Section 75W Modification

MP08_0222

Global Switch Sydney 2 Data Centre

273 Pyrmont Street, Ultimo

Approved Cross Section – 3 basements

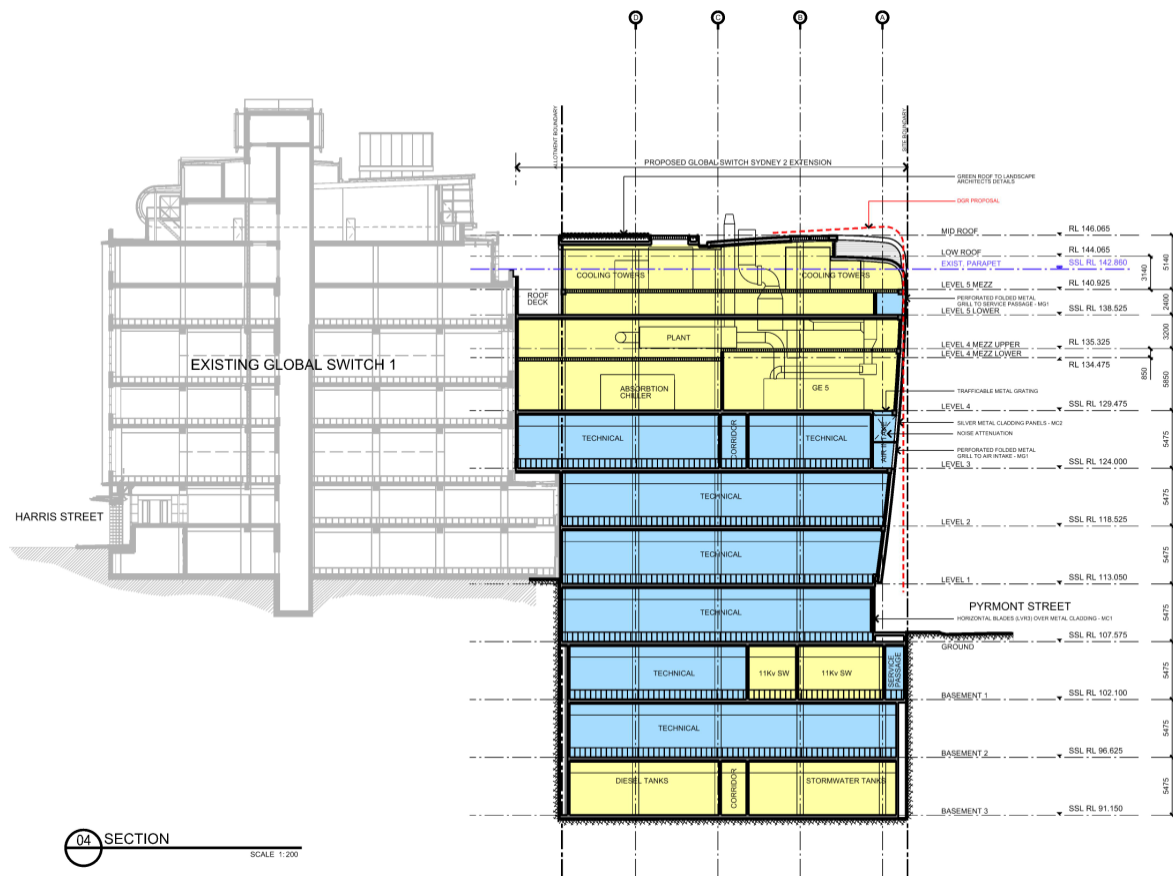
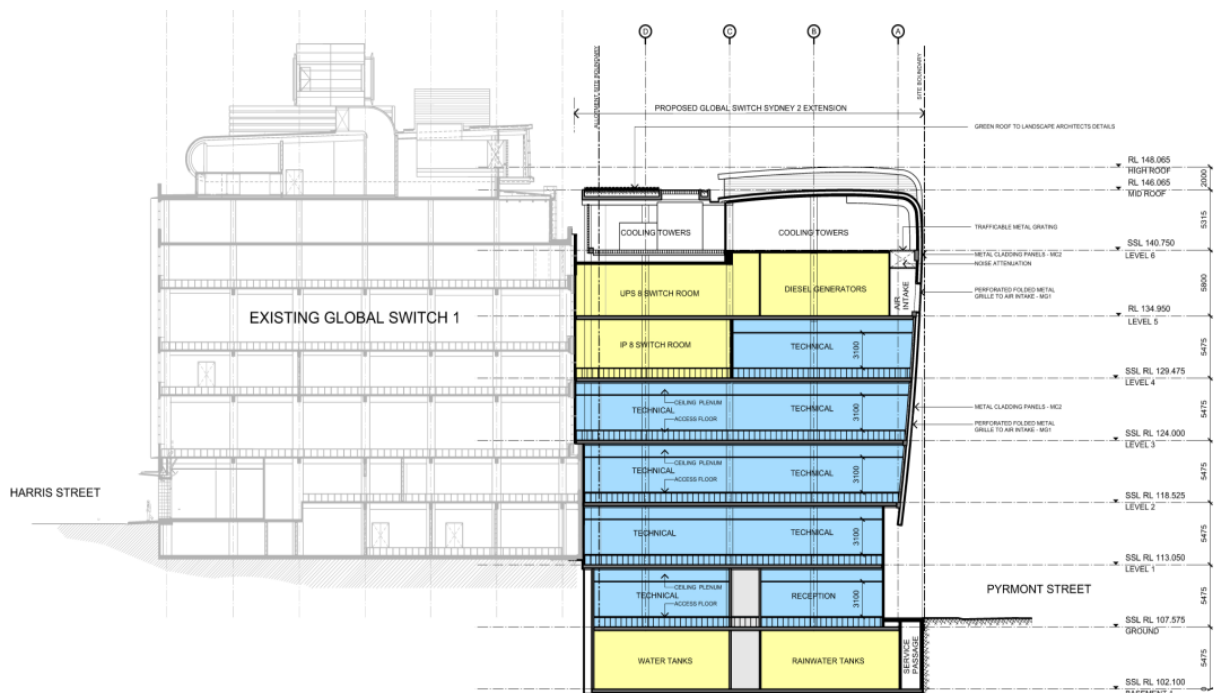
- Delete the two lower basement levels and reduce the size of the remaining basement level, thereby reducing excavation and bulk earthworks;
- Reduce the Gross and Net Floor Area of the building from 22,285 m² to 18,175 m².
- Re-configure the floor levels and space allocation of the plant rooms;
- Introduce a second lift core to accommodate the staging the building;
- Relocating the roof level breakout area to the north of the building to coincide with the new position of the lift core.

The revised gross floor area as modified is now 18,175 m² with plant area of 7,615 m² - a reduction in GFA of 4,110 m².

Modified Cross Section – 1 basement
